Soils Response Letter

Project No. A9382-06-02 October 28, 2021

Subject: RESPONSE TO SOILS REPORT REVIEW LETTER PROPOSED HIGH-RISE REDEVELOPMENT – "1360 VINE" 6254-6274 W. DE LONGPRE AVENUE, 1334 & 1348-1360 N. VINE STREET 6241 -6265 W. AFTON PLACE, LOS ANGELES, CALIFORNIA TRACT 1210, BLOCK A, LOTS 11-23

TABLE 3

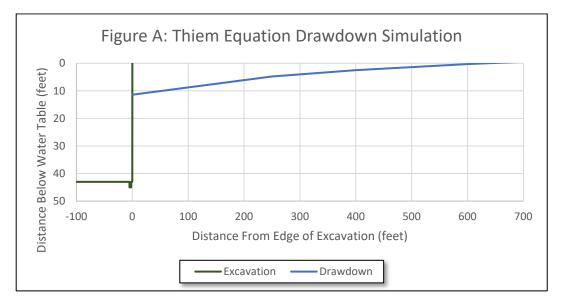
- Comment 1: Show the drawdown curve(s) on the adjacent properties and explain how was concluded that the temporary dewatering will not have any detrimental impact of the adjacent properties and structures. Support your conclusions with settlement calculations.
- **Response 1:** The discussion above addresses the proposed temporary dewatering, including a discussion of potential impacts on adjacent properties and structures and includes settlement calculations.

Our analytical evaluation is based on the Thiem equation (Domenico and Schwartz, 1990). If the Transmissivity of the aquifer is known, the Thiem Equation provides the difference between the drawdowns at any two specified locations away from the dewatering source. Our simulation is based on a presumed dewatering point in the center of the proposed building footprint. The proposed building has a maximum length of approximately 350 feet, so the target dewatering radius is 175 feet. The Thiem equation results are presented in Table 3 for the middle range hydraulic conductivity value shown in Table 1. As indicated in Table 3, the drawdown will be effectively zero at a distance of 600 feet from the edge of the shoring. Figure A shows the profile of the drawdown surface relative to the excavation.

Distance from Edge of Excavation	Drawdown (feet)
0	11.4
250	4.5
400	2.5
600	0.3
